STAFF REPORT

Staff Report OSLO BAY APARTMENTS SITE PLAN REVIEW and BOUNDARY LINE ADJUSTMENT

To: Heather Wright, Poulsbo Planning and Economic Development Director
From: Karla Boughton, Special Projects Planner
Date: August 12, 2022
Subject: Oslo Bay Apartments | Site Plan Review | P-12-05-19-01

Figure 1: BLA Before and After Configurations

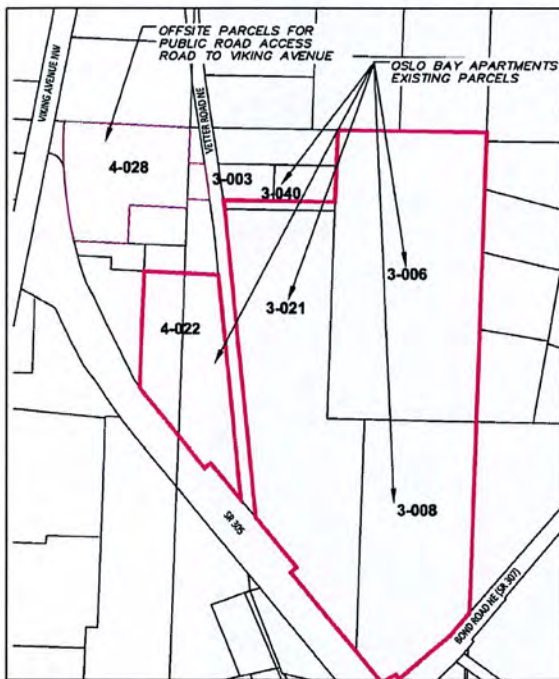
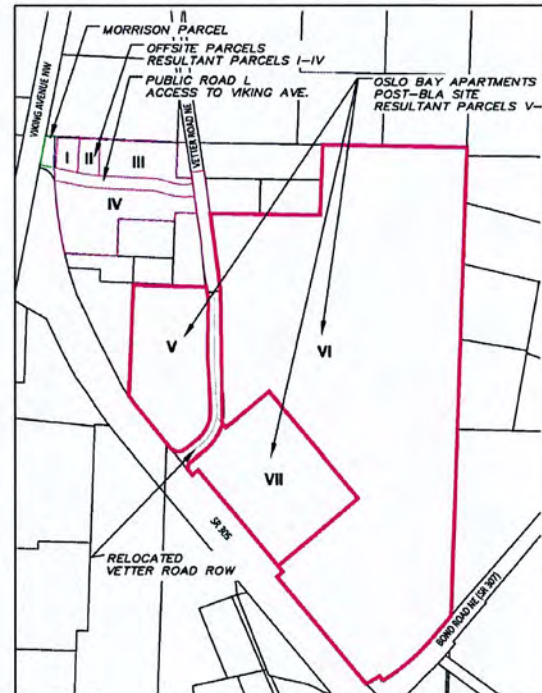
In Figure 1 below, Parcels after BLA, parcels I-IV are identified as off-site area and parcels V-VII are identified as on-site. The site and off-site parcels are noncontiguous but connected by Vetter Road ROW. Proposed improvements to the off-site parcels include only the construction of the new road L connecting Vetter Road NE to Viking Avenue NW. Improvements to the on-site parcels include the proposed apartment buildings and associated roads, utilities, parking, landscaping, and recreation amenities.

Figure 9: Site Plan with highlights of on-site vehicle circulation and parking bays examples

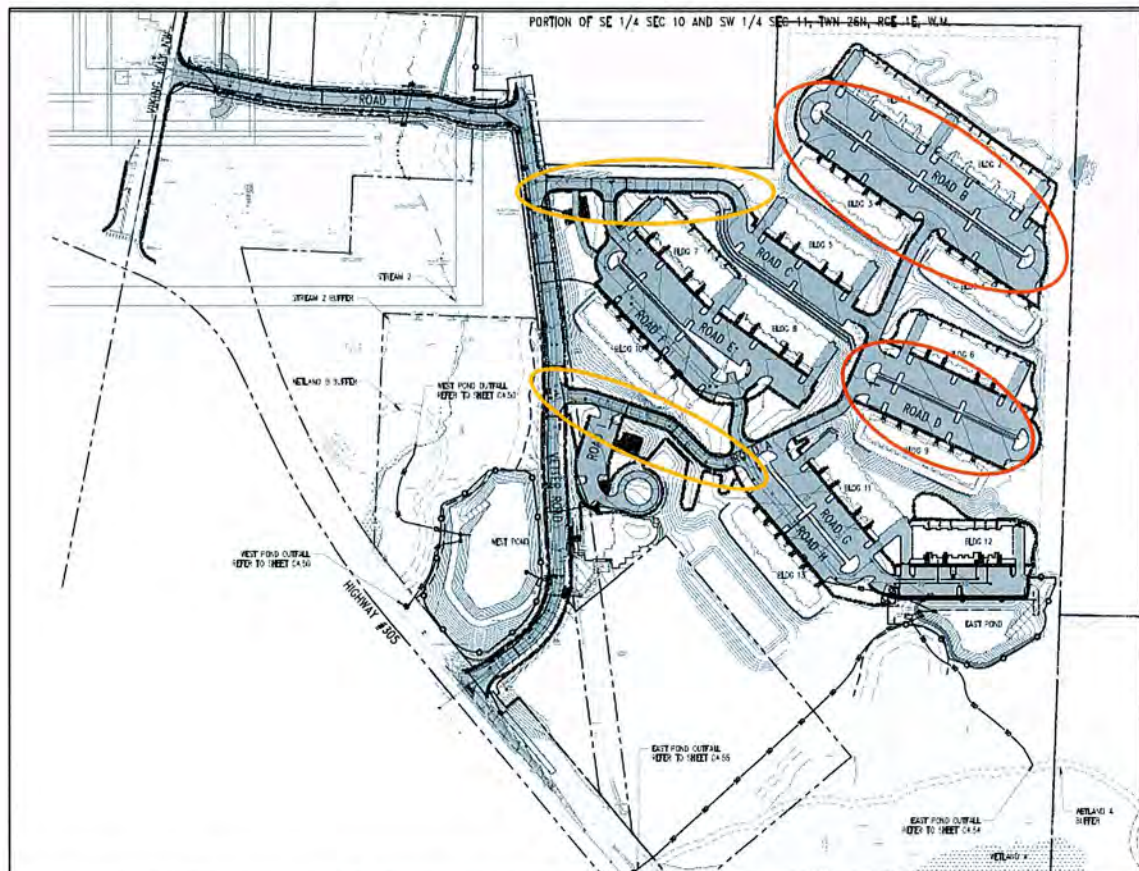
Staff Comment: On-site circulation is through several private streets that loop the development and circulate through a series of parking bays. The private streets must meet fire access road requirements. The private streets "Road A" and "Road C" connect to Vetter Road. The parking garages are not visible from the traveled way through the parking bays. The parking area for the Community Center is located 15' from Vetter Road NE and is screened by a landscaped buffer.

Figure 12 Before and After BLAs Configurations

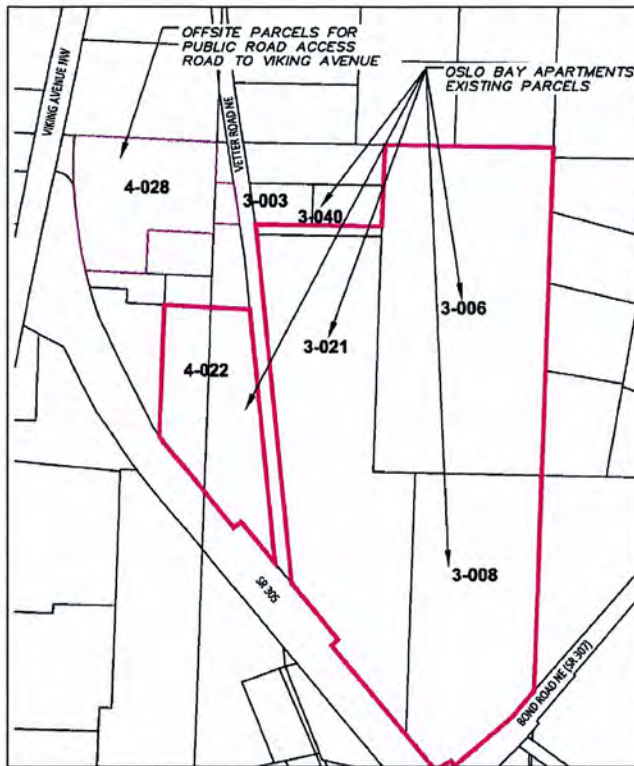
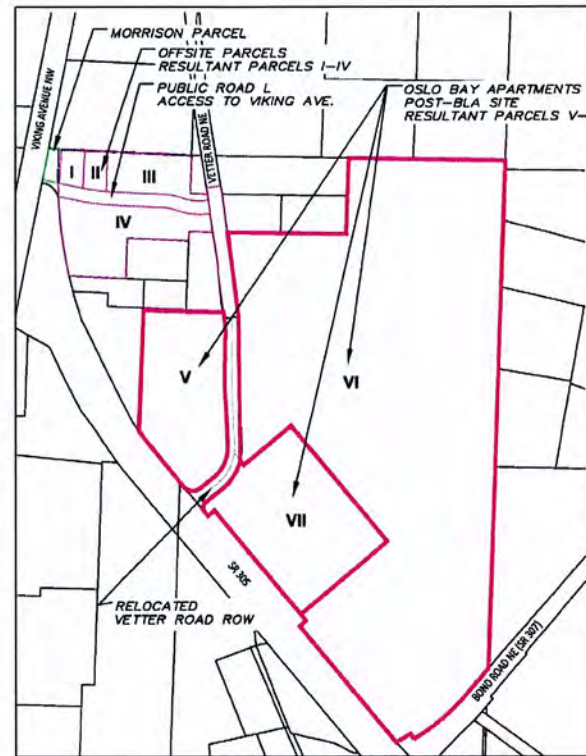
Staff Comment: The Oslo Bay Apartments project includes boundary line adjustments between lots owned by Edward Rose (project site), and a boundary line adjustment between Resultant Lot I and the adjacent "Morrison" property.

- The boundary line adjustments within the Edward Rose parcels result in Parcels I, II, III and IV and are considered off-site parcels, but is where Road L and the Western Stream are located. Parcels V and VI are the Oslo Bay Apartments parcels, and Parcel VII is considered part of the project, but will be where a future senior apartments project is to be located.
- The boundary line adjustment between Resultant Parcel I and a lot owned by James B Morrison Family LLC (tax parcel 102601-4-038-200). This BLA facilitates a public road connection of Road L to Viking Avenue NW that is coincident with the Arco/Sonic driveway.

Figure 13: Before and After BLAs Zoning

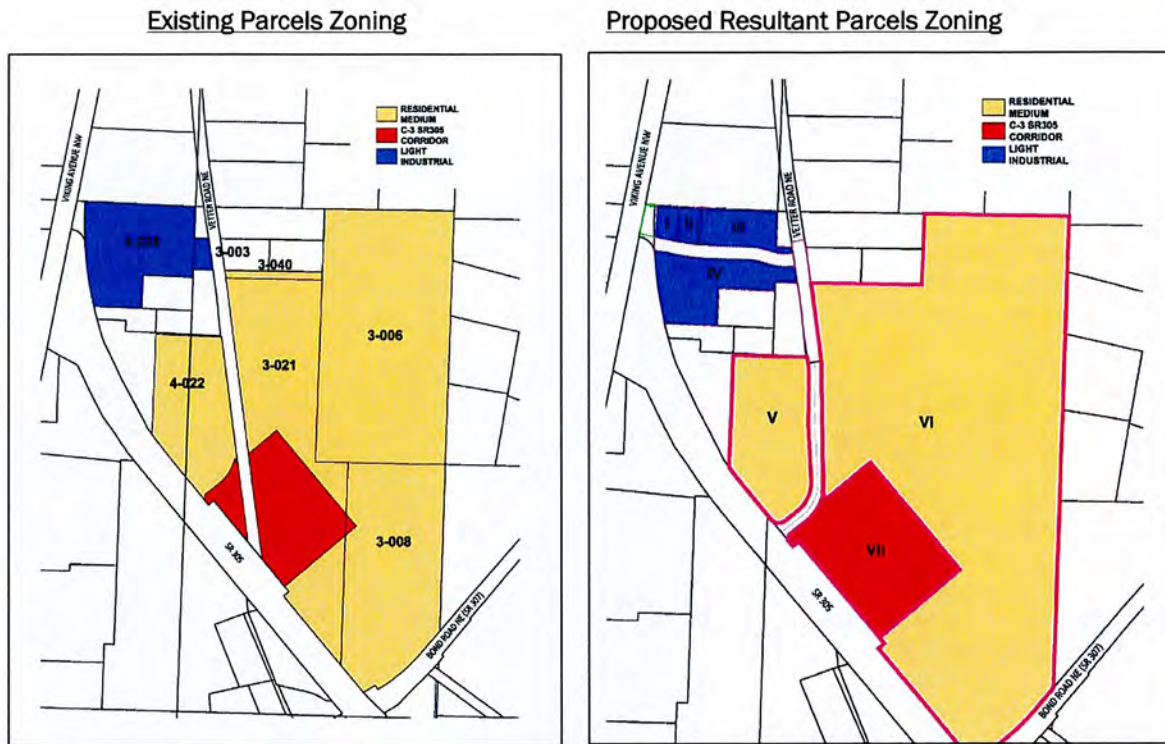
Staff Comment: The boundary line adjustments between the off-site parcels (I-IV) and between Parcel I and Morrison, are all zoned Light Industrial, and therefore no parcel will result in being located partially within and partially outside of any zoning.

On-site parcels V and VI are zoned Medium Density and Parcel VII is zoned commercial. The vacation and realignment of Vetter Road will modify and straighten Parcel VII's boundary but will not result in any parcel having more than one land use designation or zoning.

Figure 16: Road L Stream Crossing

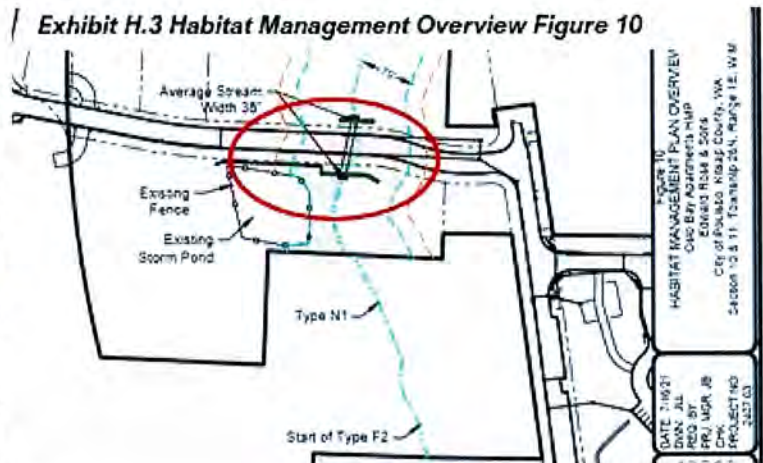
Road L Stream Crossing and Buffer Impacts: Road L will require a perpendicular crossing of the Western Stream Type Ns1 stream section with an 84" diameter, 94' long culvert. (See Figure 16 below.) The culvert has been sized to accommodate flows that exit the culvert emerging at the north line from the Kitsap Transit Center. The culvert will span at a narrow segment of the stream channel. Wing walls will help direct water flow into the culvert and avoid stream flows bypassing the culvert. The proposed culvert will be placed at a grade of 3.4 percent, which closely represents the current grade of the stream. Streambed gravels sized per WDFW specifications will be spread within the culvert. It is projected that approximately 55 cy of dredged material will be removed, and 55 cy of fill will be replaced as part of the Road L crossing. [Exhibit H.3 Habitat Management Plan](#) includes the "Stream Crossing Detail" as Figure 5 (pdf page 31).

Figure 20: FEMA Flood Insurance Rate Map depicting Flood Hazard Area

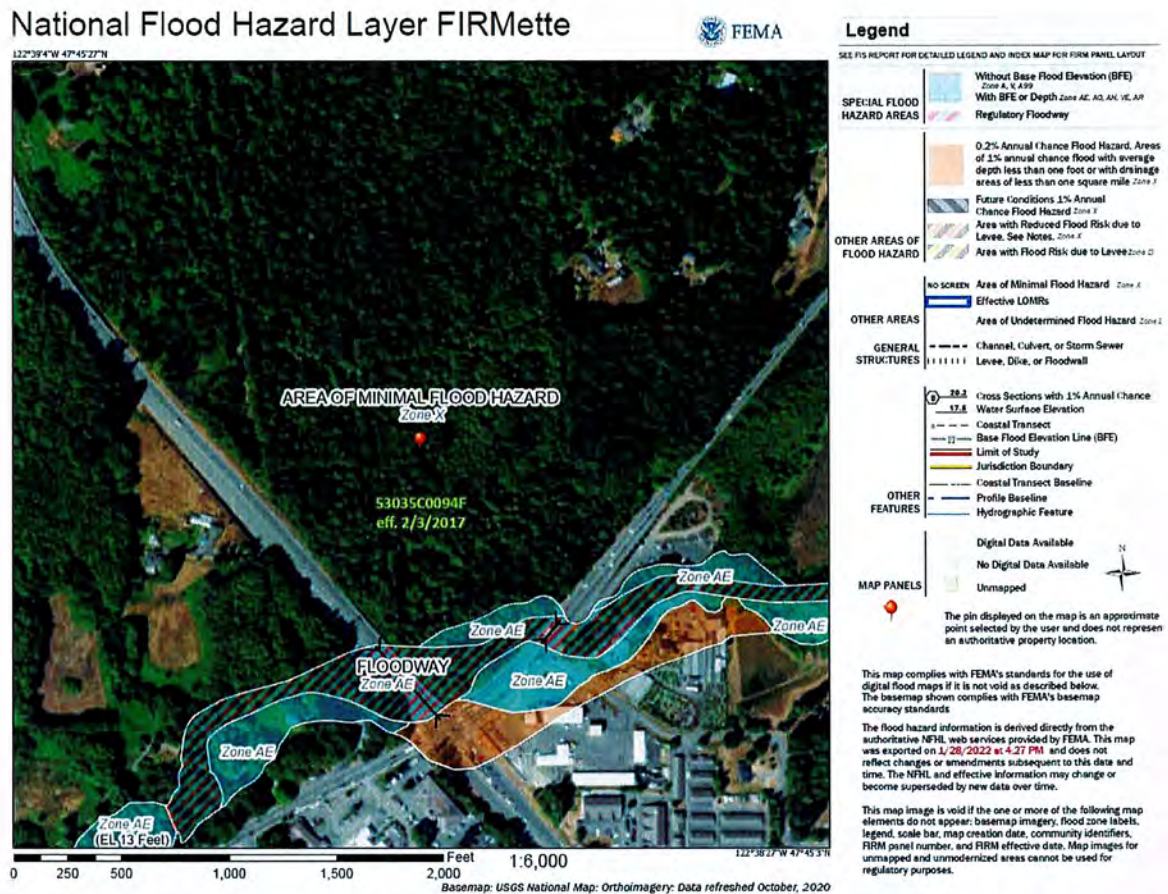
Staff Comment: No impacts are identified to the 100-year Floodplain zone as site development is over 600' from the flood zone and Dogfish Creek.
